PLANNING DEVELOPMENT PROPERTY

**RE: Proposed S4.55(1a) Application for the Modification of Consent for SSD8440 for Amendments to the Floor Plans for Mixed Use Development (Hotel, Serviced Apartments, Residential and Carpark)**

**Our Ref: 17058**

**Figure 2 – Approved First Floor Plan and Proposed Modification to First Floor Plan**

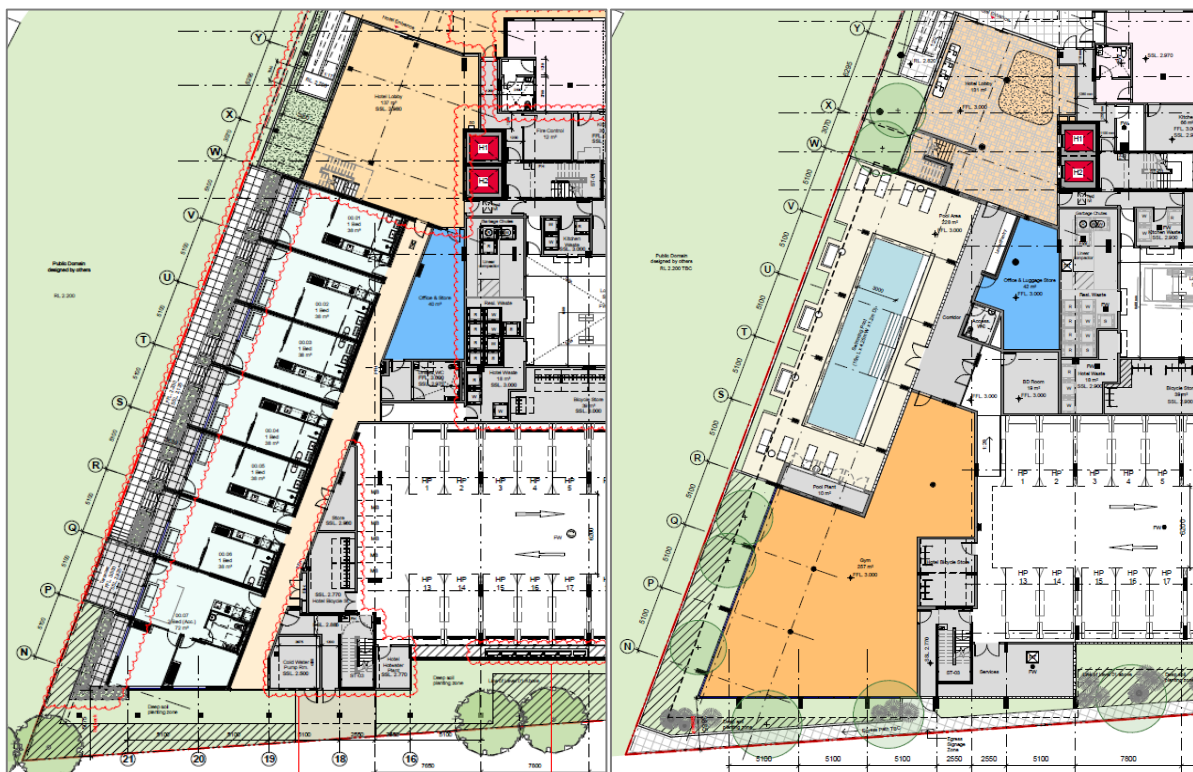
Figure 2 below shows the existing approved floor plan for the lower level. The extent of the changes include modification of the ground floor on the western side of the building. The changes predominantly relate to the removal of serviced apartments and replacement with a gym, swimming pool and service rooms. This will also include the extension of the ground floor to the south to encompass the area under the external columns to fill in the building line from the unit above.

The proposed change will result in the net decrease of 7 serviced apartments.

**Figure 3 – Approved Floor Plan and Proposed Modification to Floor Plan**

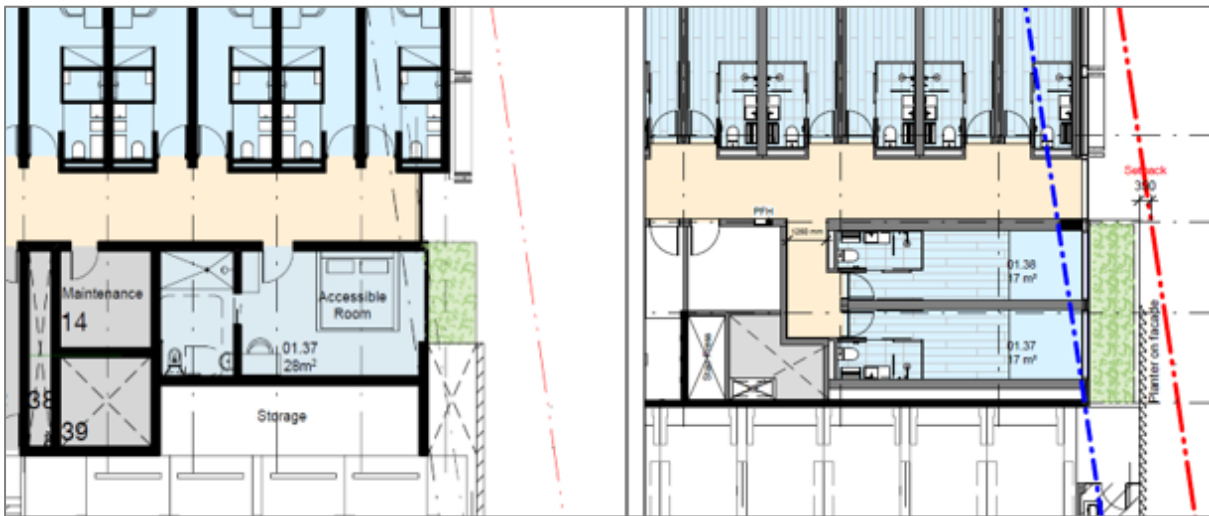
Further changes are proposed to the accessible units (1.37, 2.37, 3.37) on floors 1 to 4 on the eastern portion of the building. It is proposed that the existing single bed accessible unit be altered to contain 2 single bedroom units running on an east/west orientation. The landscaping outside the windows have also been adjusted. Figure 3 below show the existing floor plan on level 2, and the proposed floor plan. This format for the units will be replicated on the floors above.

The extent of the proposed changes will result in the net increase of 4 hotel rooms.

Figure 4 – Approved Northern Elevation and proposed Northern Elevation.

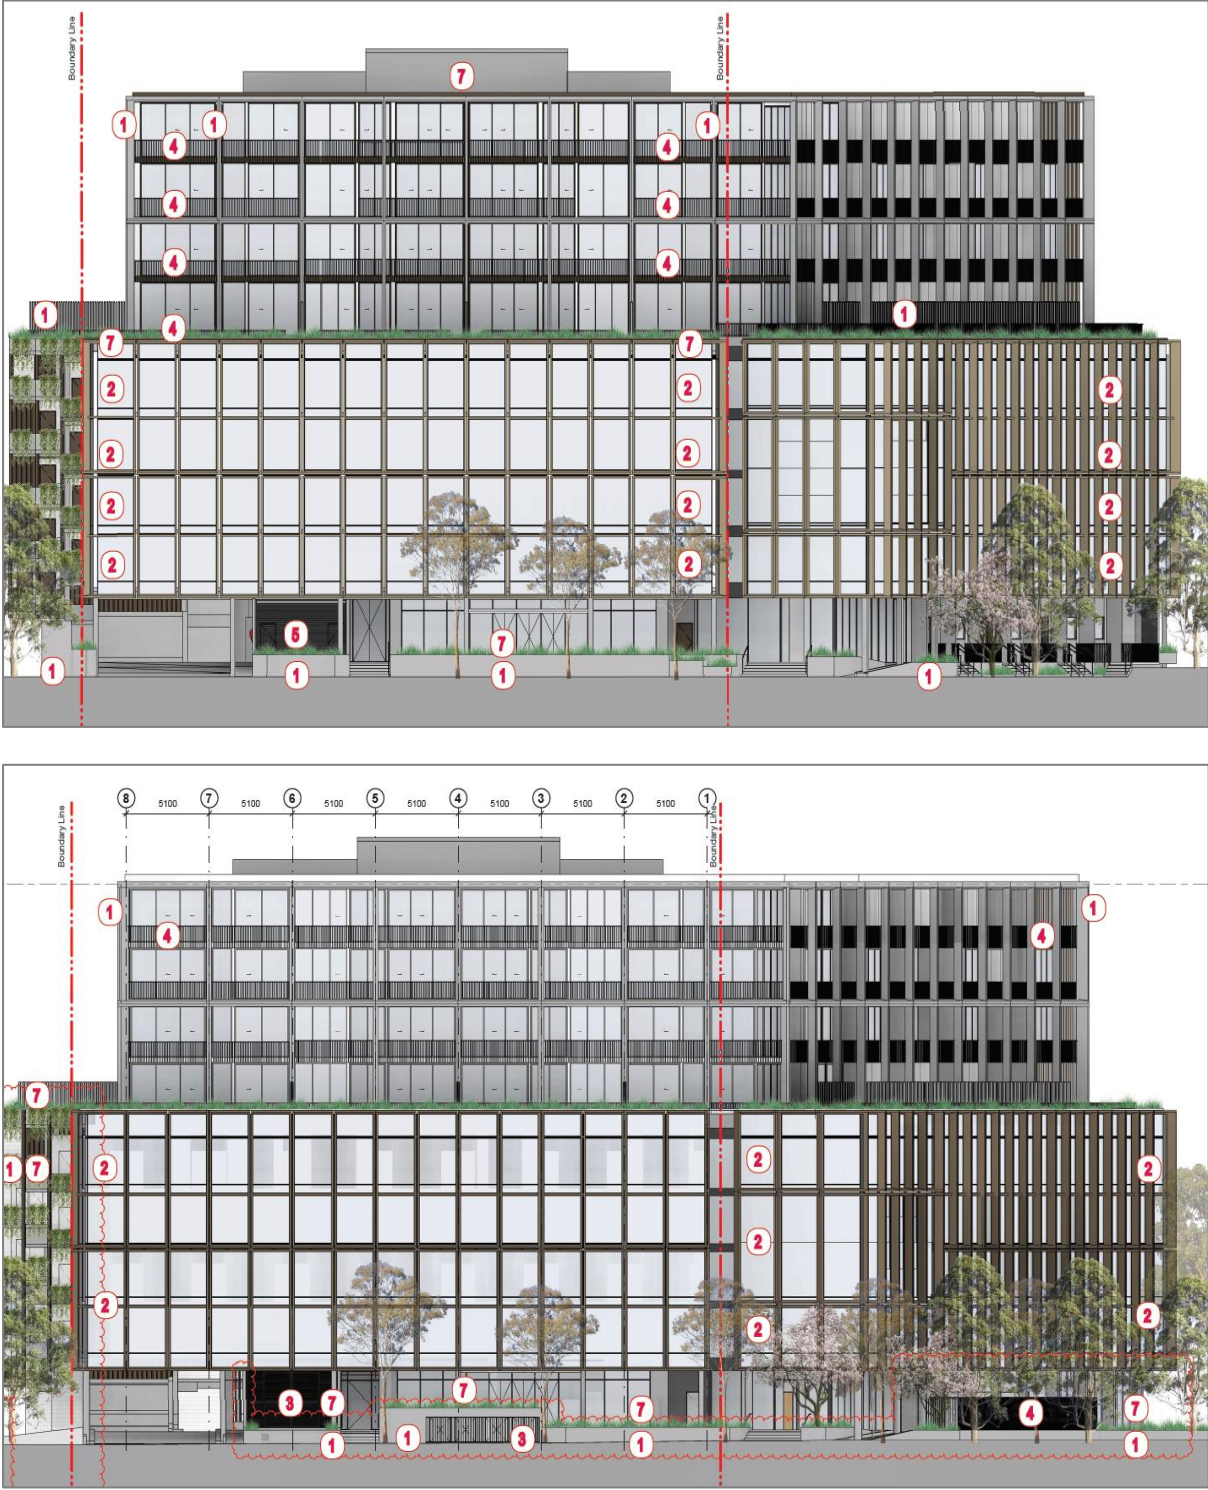
There will be no significant impacts caused on the visual impact of the building as a result of the proposed modification. The modification is wholly contained within the existing footprint of the building. The impacts that the development will have from a visual impact are shown in figures 4, 5, 6 and 7 below which demonstrate the minor visual impacts.
